1968 Corvette: Service Bulletin: Choke and Hot Restart Problems

Model and Year: 1968 Corvette with 427 cu. in. Engine

Bulletin No: 68-T-23 Re-Issue

Date: Apr. 24, 1968

FIGURE 1

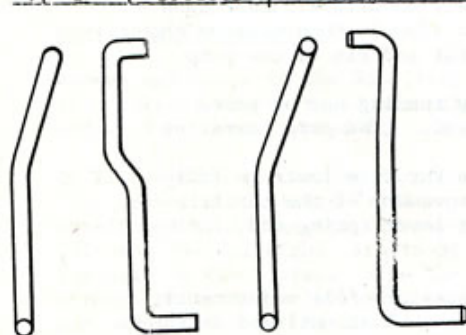
427 Cu. In. 390 H.P. Engine

Install new choke rod (Part No. 3937738) which has a greater off-set and a reverse entry direction at the choke lever end. Adjust to one rod diameter interference by bending at the off-set as necessary.

FIGURE 2

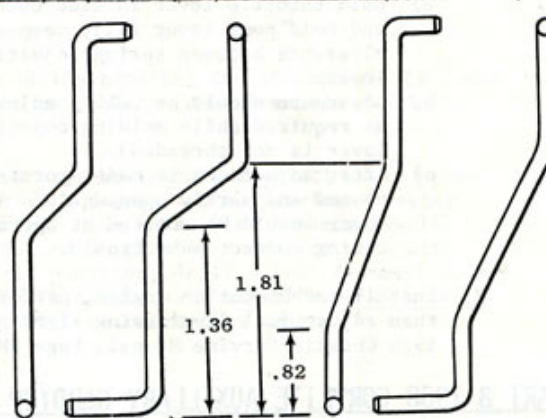
427 Cu. In. - 3 x 2 Carburetor Engines

Install new choke rod (Part No. 3919899) which has a greater off-set leg length and check for interference between choke thermostat coil and the manifold pocket as shown in Figure 3. If interference exists in this area, adjust the coil as much as possible on its mounting location, and if necessary, grind the pocket area or the choke rod end to gain clearance needed.

FIGURE 3

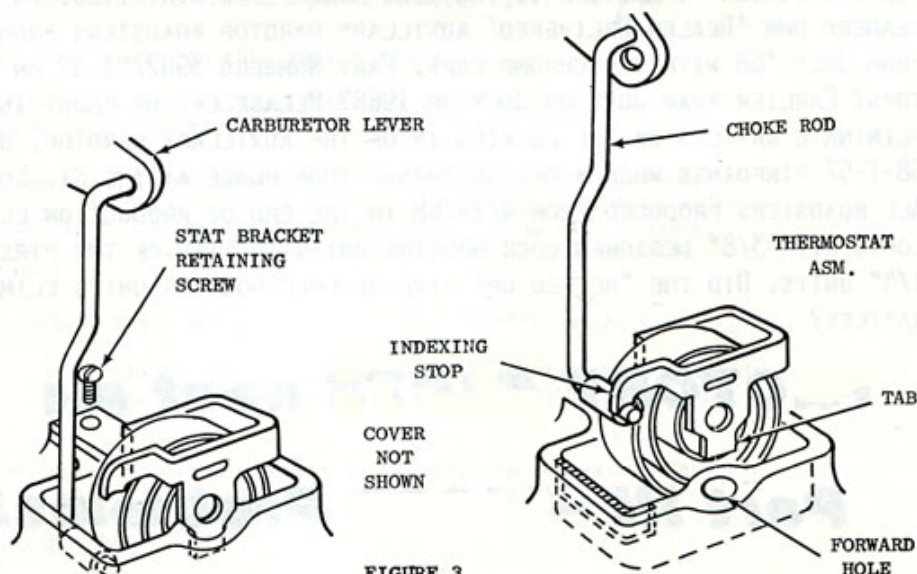
Installation of fuel bowl external idle vent - Holley 3 x 2 primary carburetor.

1. Remove Primary Carburetor from engine.
2. Remove Fuel Bowl Assembly
3. Install vent valve, rod, clip and spring on new fuel bowl.
4. Transfer all float bowl components from existing bowl to new bowl and make preliminary float level adjustment.

5. Install new bowl on carburetor with new bowl and body gaskets
6. Adjust idle vent valve as follows:
 - a. Back off idle speed screw until throttle valves are fully closed.
(Choke valve open and throttle arm off idle screw).

- b. Check clearance between vent valve and seat (.065").
 - c. Bend air vent valve rod to adjust.
 - d. Turn idle screw in until contact is made with throttle lever, then turn screw in 1-1/2 additional turns for preliminary idle speed adjustment.
